City of Canby

Staff Report File #: DR 20-02 / PAR 20-02 – Baker Center

HEARING DATE: August 10, 2020

Applicant Request

1
G1.1 PRELIMINARY PLAT MAP
 1" = 50'-0"

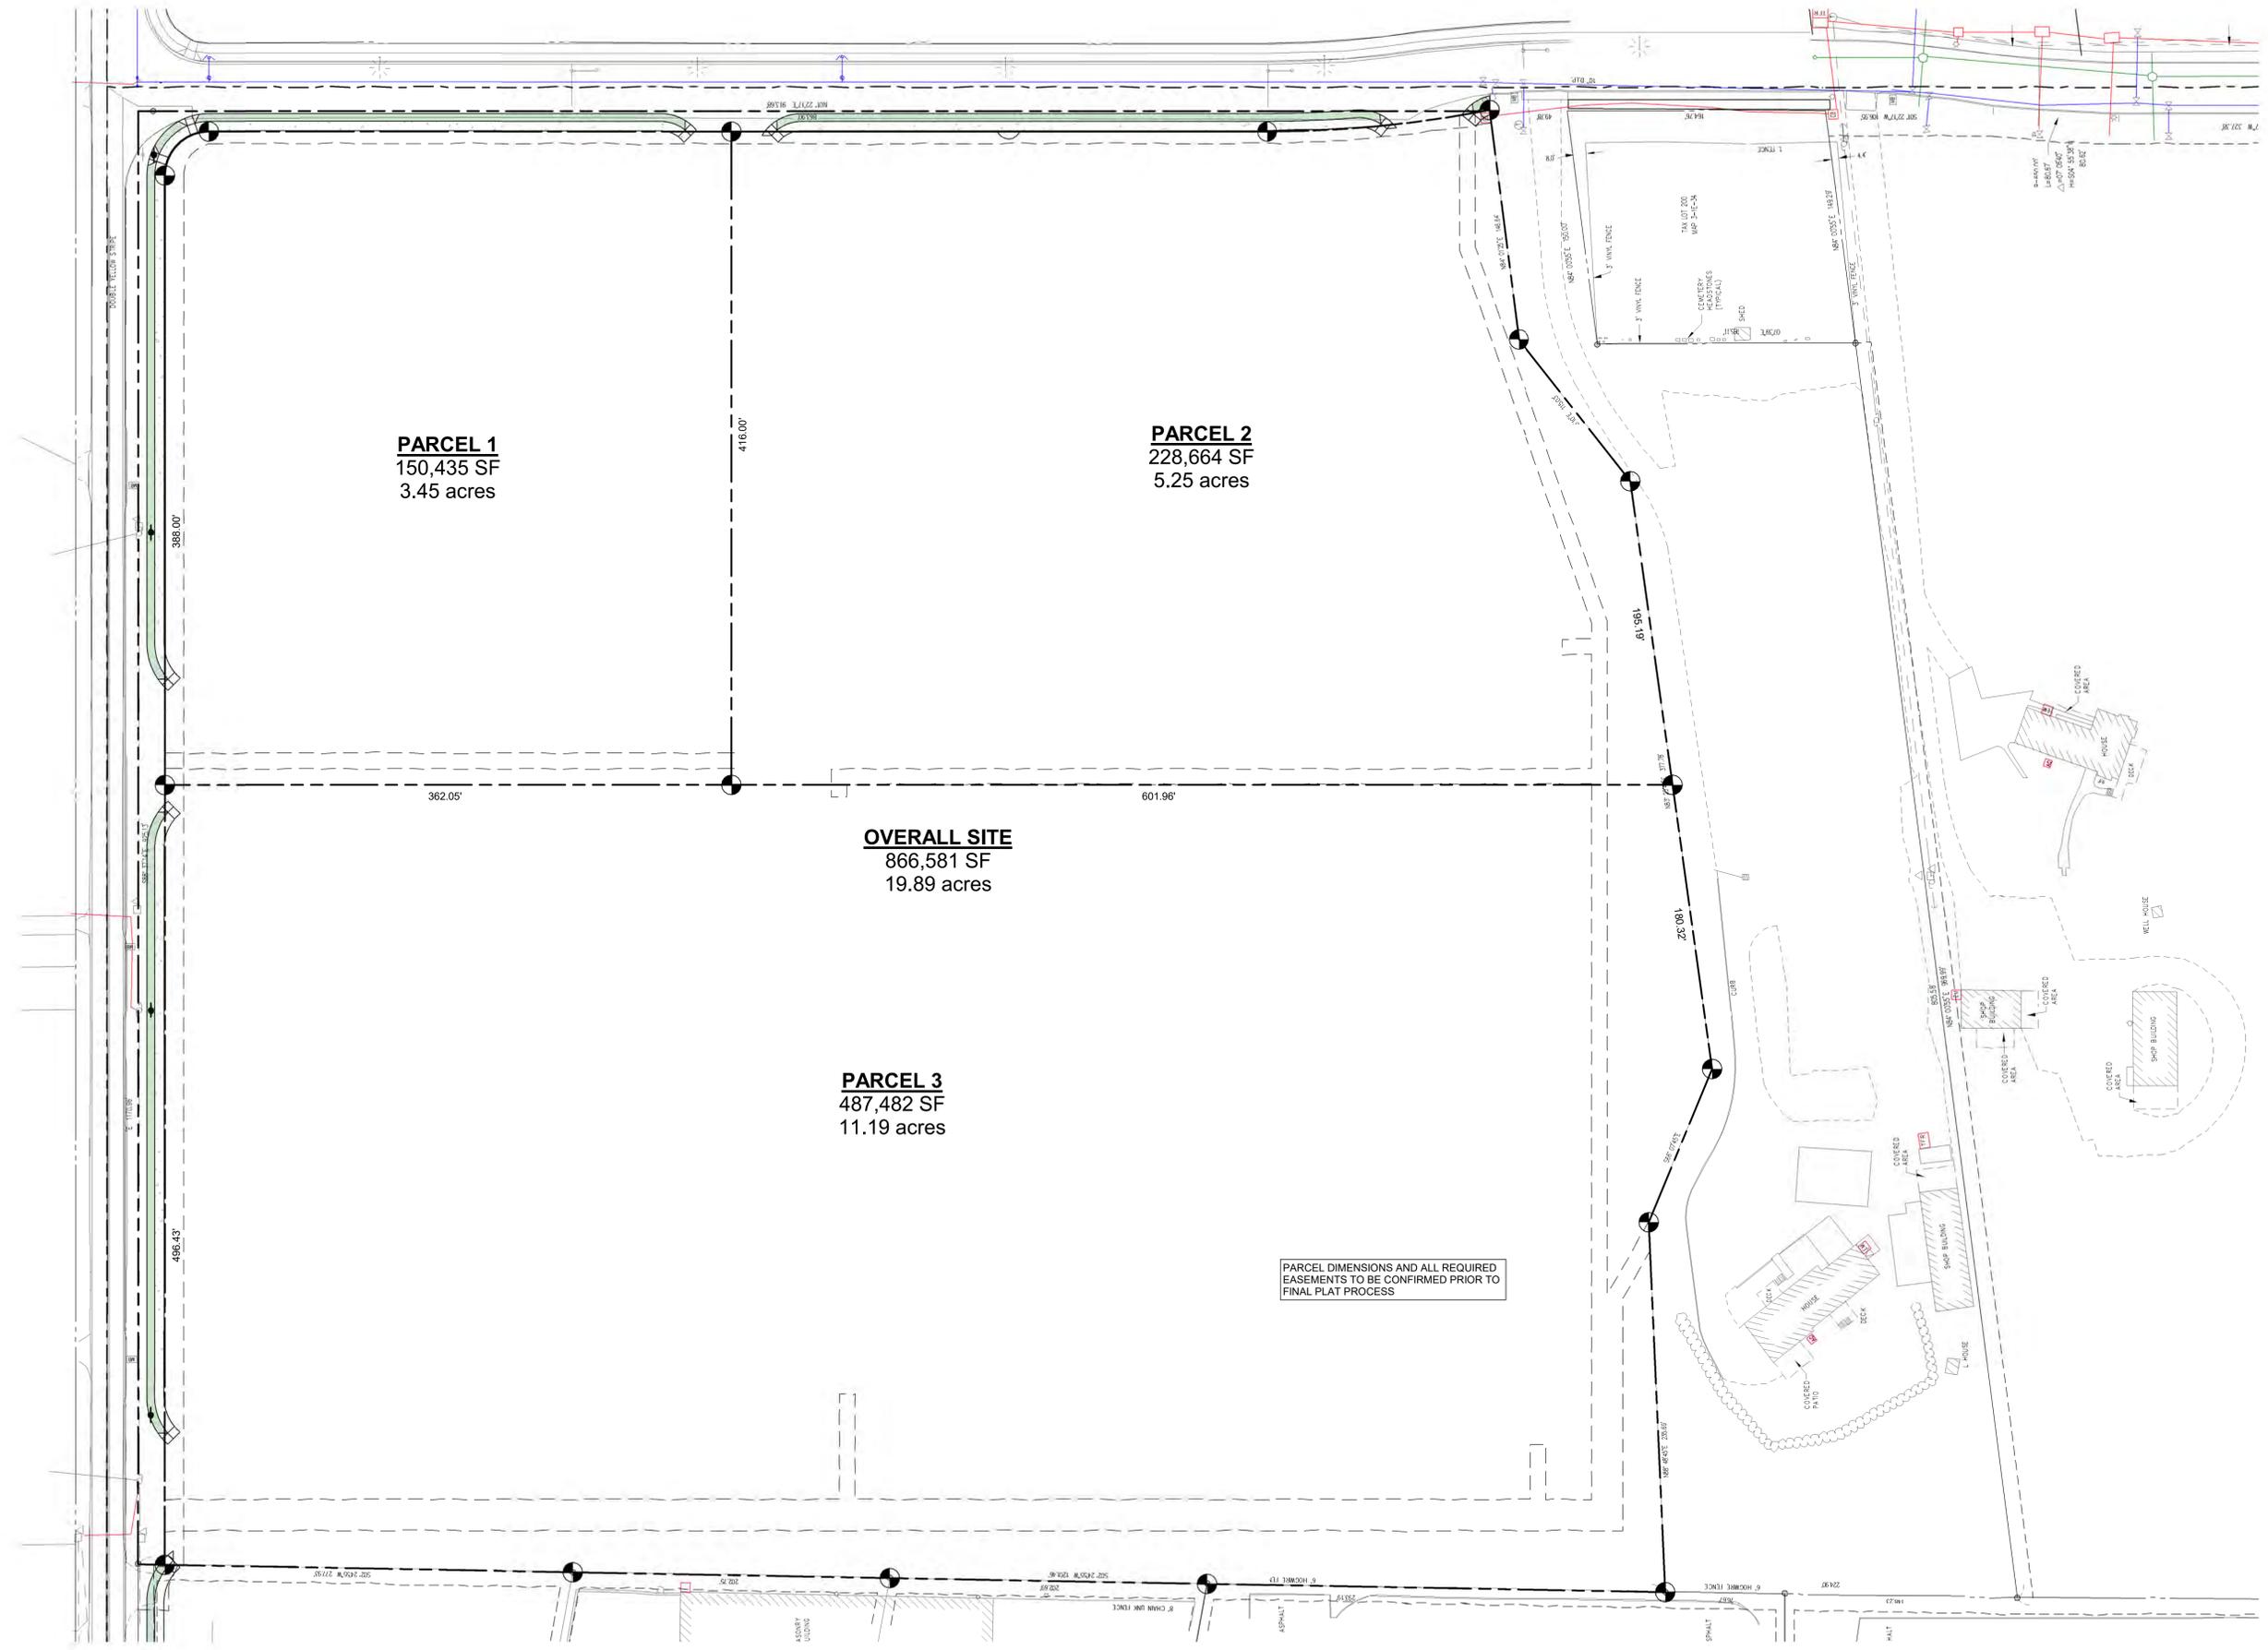
6. Right-of-way dedication shall be required at the intersection of SE 1st Avenue and S Walnut Street to accommodate the future turnabout as part of a planned extension of S Walnut Street to Highway 99E. Prior to approval of construction documents for public improvements related to the proposed project, the project design shall be modified to reflect the design of the future turnabout as shown in construction drawings provided to the project applicant by the City Engineer. (H. Ibrahim)

21. The applicant shall apply for final plat approval at the City and pay any applicable City fees to gain approval of the final partition plat. Prior to the recordation of the final plat at Clackamas County, it must be approved by the City and all other applicable agencies. The City will distribute the final plat to applicable agencies for comment prior to signing off on the final plat if deemed necessary. (R. Potter)

1 G1.0 MASTER SITE PLAN - SCHEME 8.1
 1" = 50'-0"
 0 50 100 150

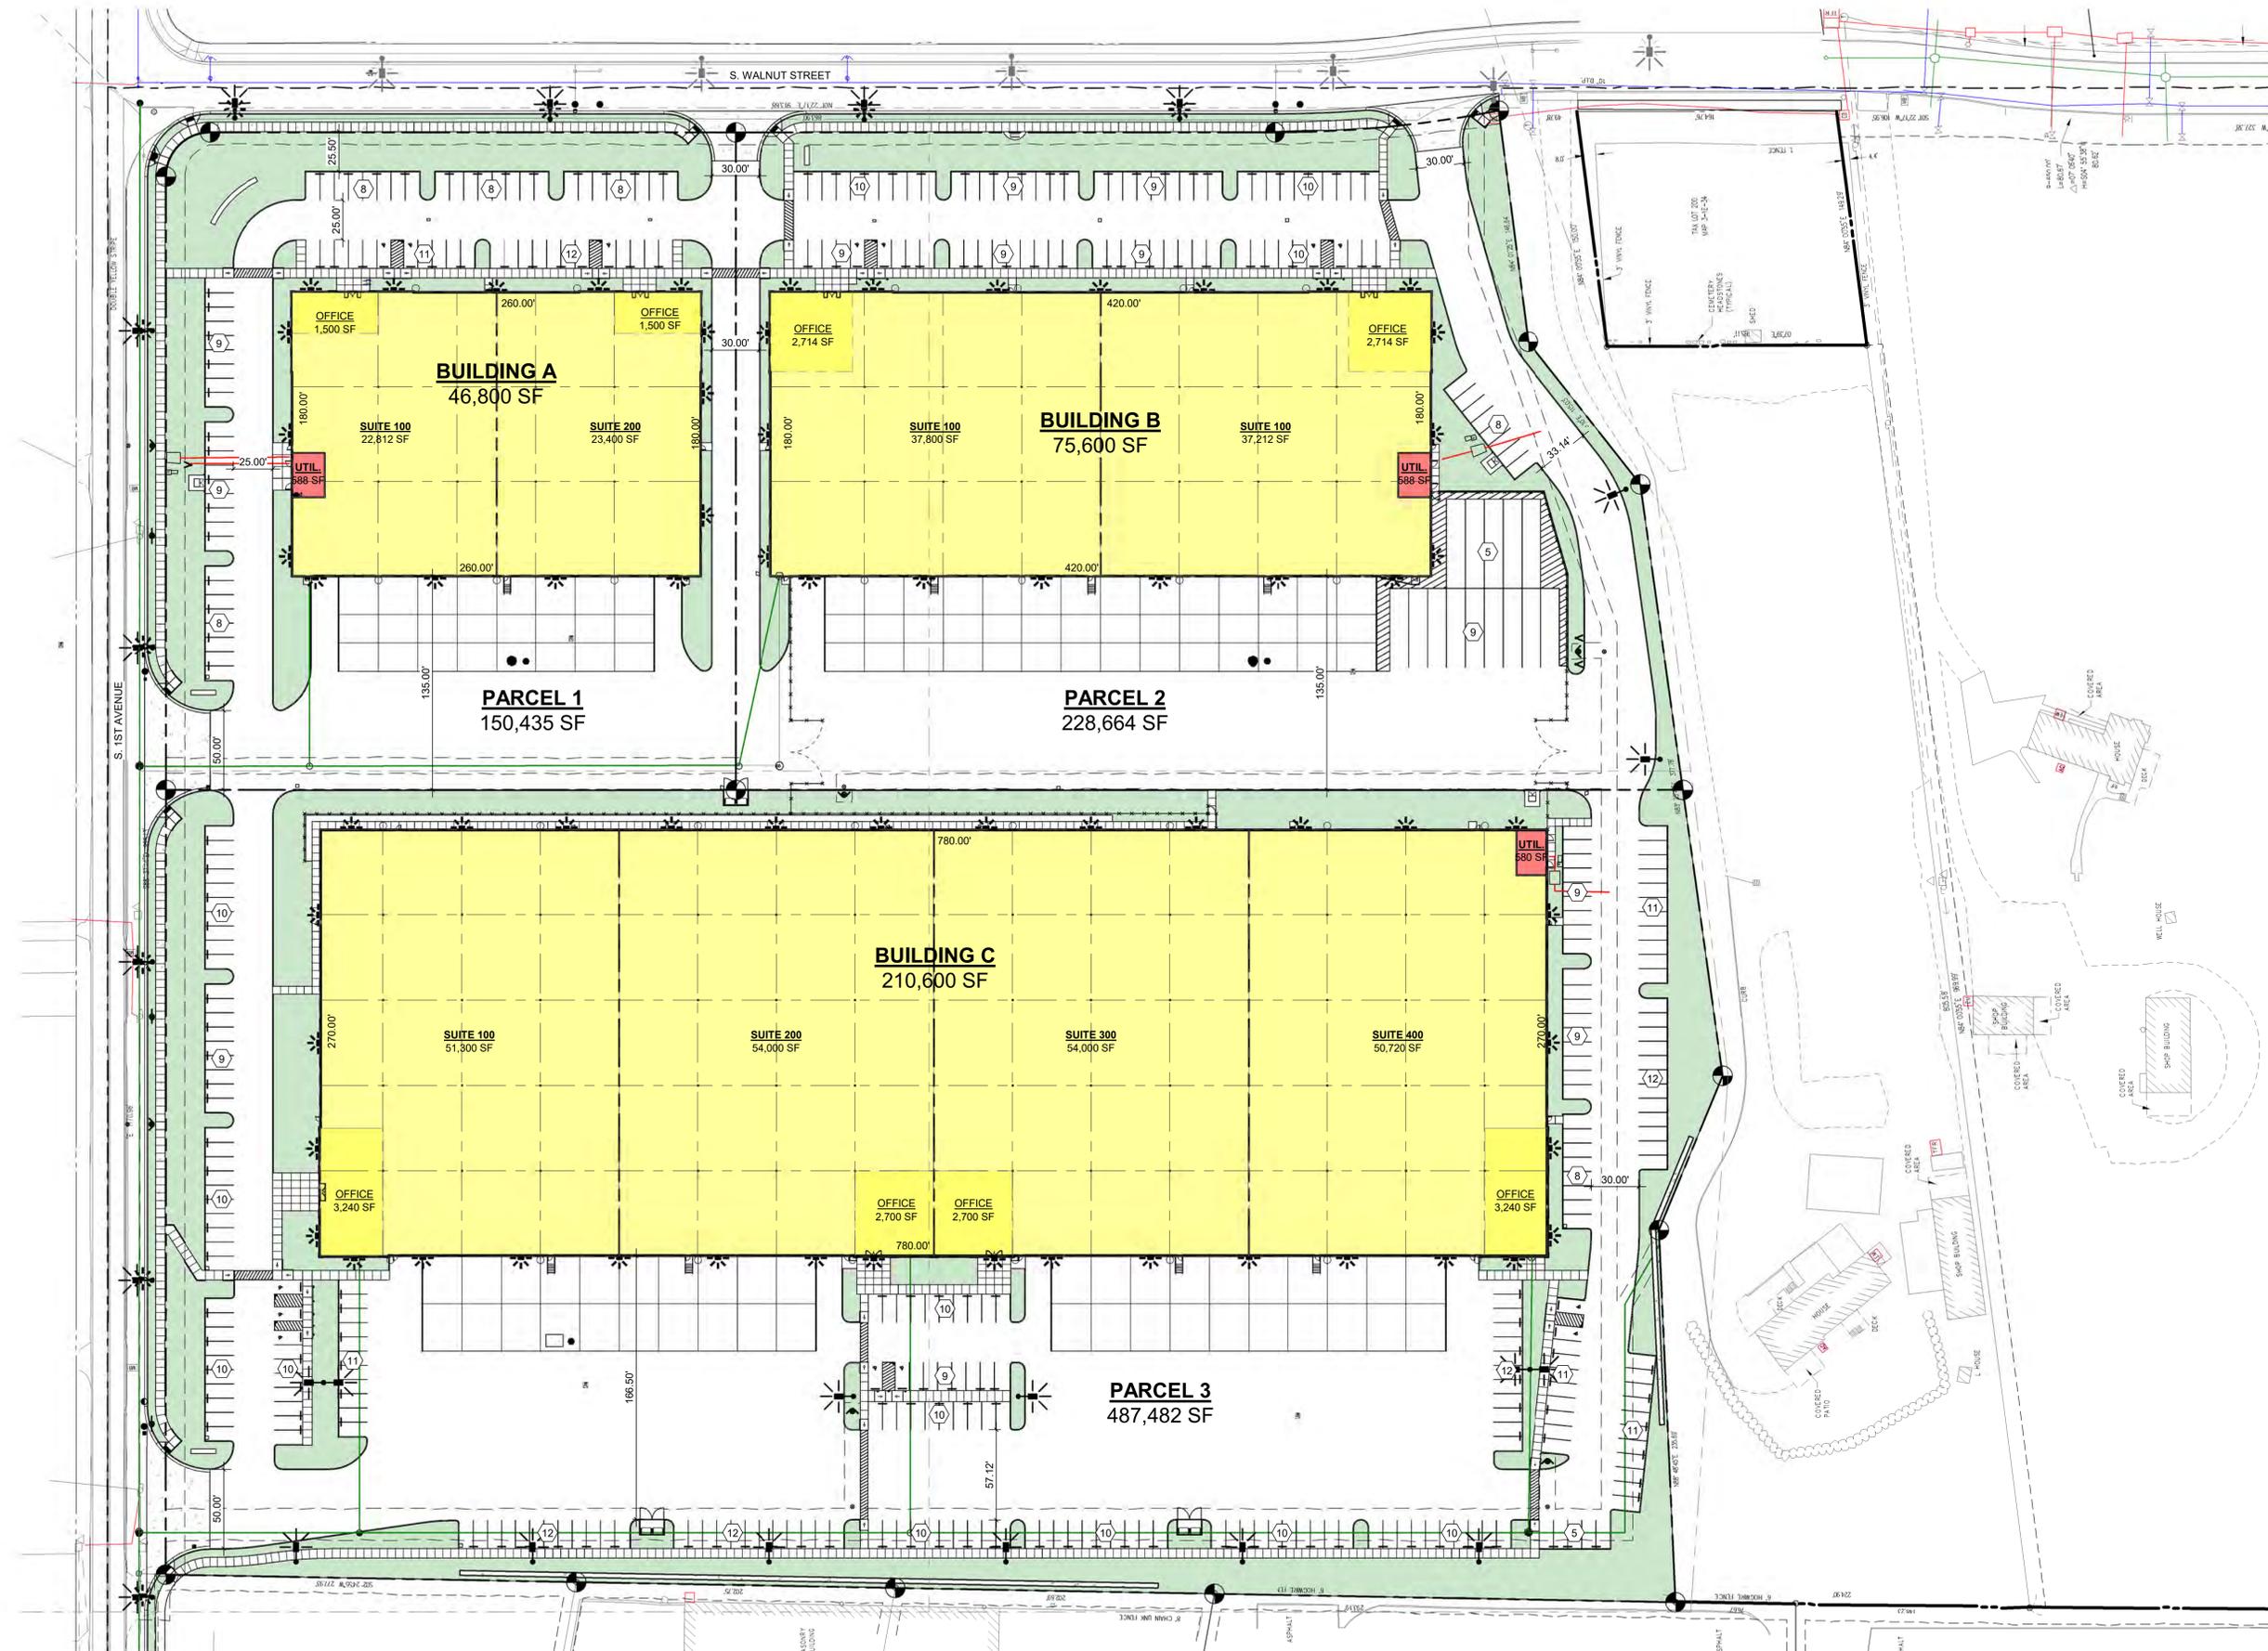
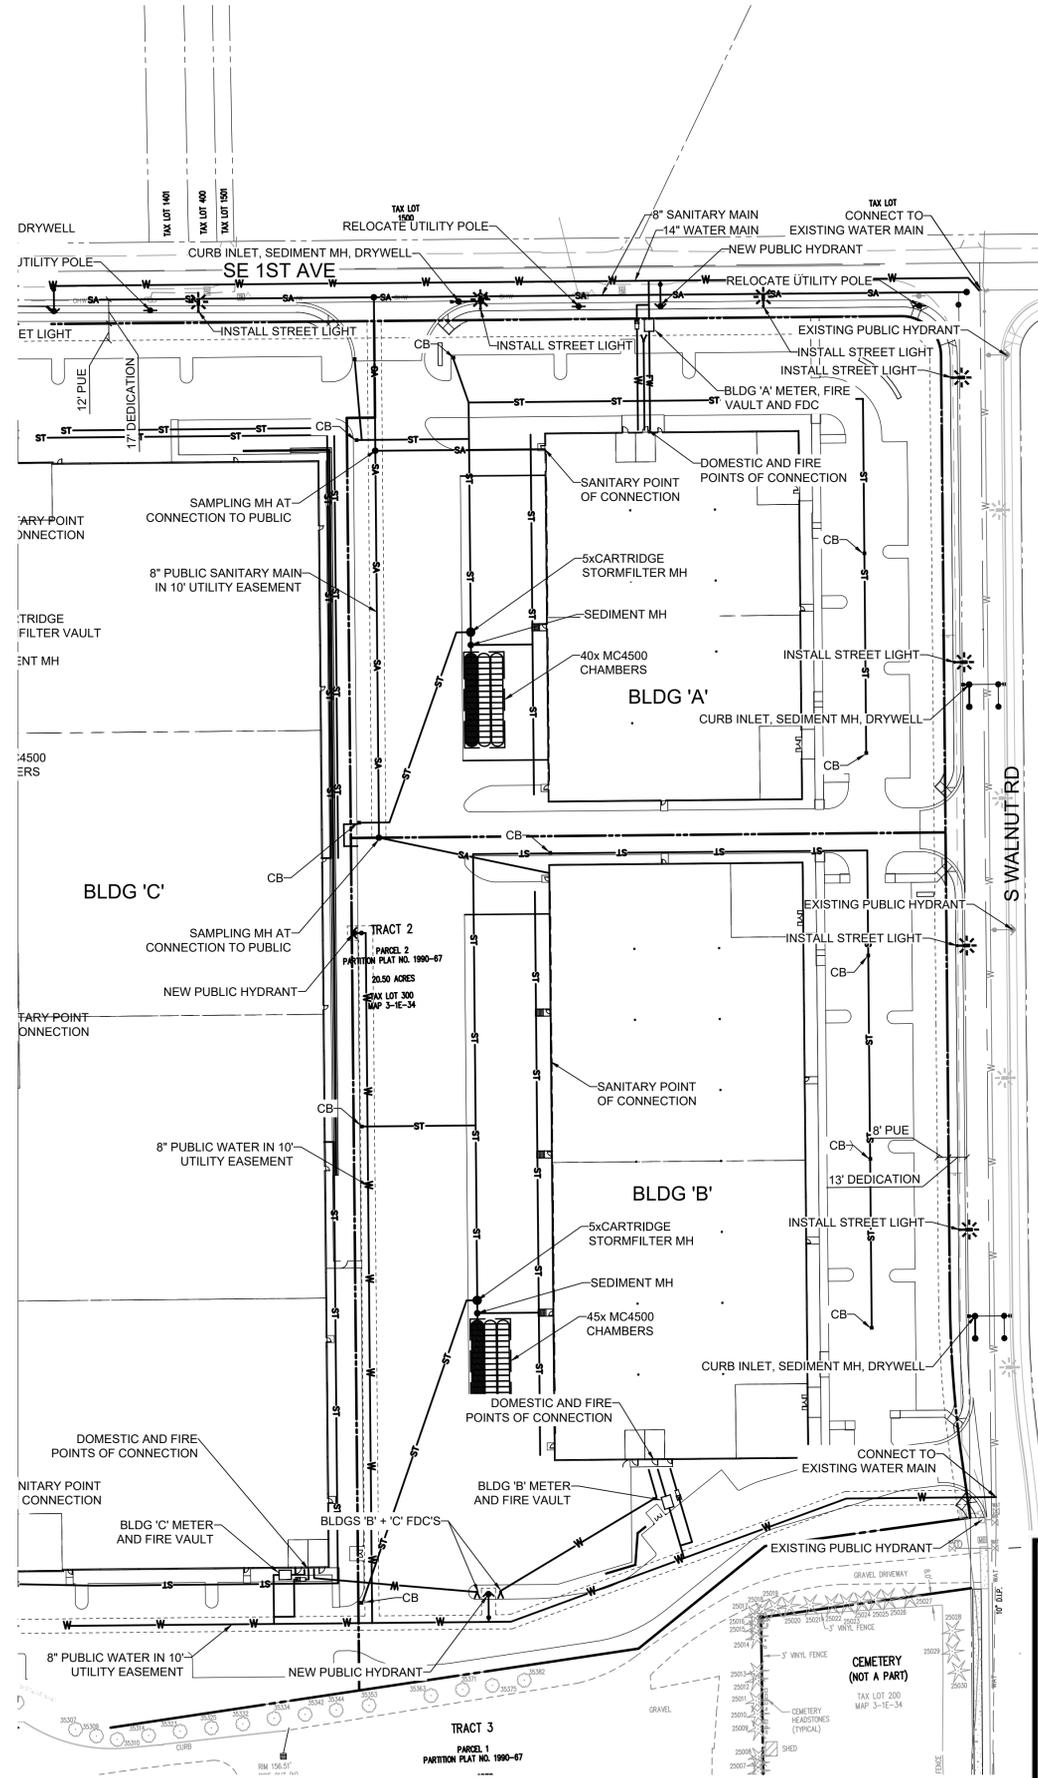
Submitted design drawings for the proposed project do not identify bicycle parking, provision of which is required by the Canby Municipal Code. Section V of this Staff Report includes a condition of approval requiring that the project design be modified to include bicycle parking as required.

Subsection 16.49.120 (E) requires all parking areas with more than 16 spaces shall include landscaping islands to “break up the parking area into rows of not more than 8 contiguous parking spaces.” This requirement is not met by the proposed project, which includes rows containing 9 to 12 spaces. Section V of this Staff Report includes a condition of approval requiring that the project design be modified to comply with this standard.

As discussed on Page 5 of this Staff Report, the surface parking proposed for the project site will be required to be reconfigured in order to provide additional landscaped islands as required by the Canby Municipal Code. This may affect the project’s overall parking count. However, because the project design currently has substantially more parking than required, this reconfiguration is not expected to result in an overall deficiency in parking. Final site plans for the proposed project shall demonstrate this compliance.

31. Consistent with Subsection 16.10.100, *Bicycle Parking*, of the Municipal Code, the proposed project shall be modified to provide bicycle parking within 50 feet of the main entrance of each building. Prior to site plan approval, the project applicant shall submit a final site plan demonstrating that the location and design of proposed bicycle parking conforms to the aforementioned code section. (R. Potter)

32. Consistent with Subsection 16.49.120, *Parking Lot Landscaping Standards*, the proposed surface parking shall be redesigned to “break up the parking area into rows of not more than 8 contiguous spaces.” Prior to site plan approval, the applicant shall submit to the City a revised site plan demonstrating compliance with this condition, along with revised landscaping calculations reflecting the change in site design/lot coverage. (R. Potter)
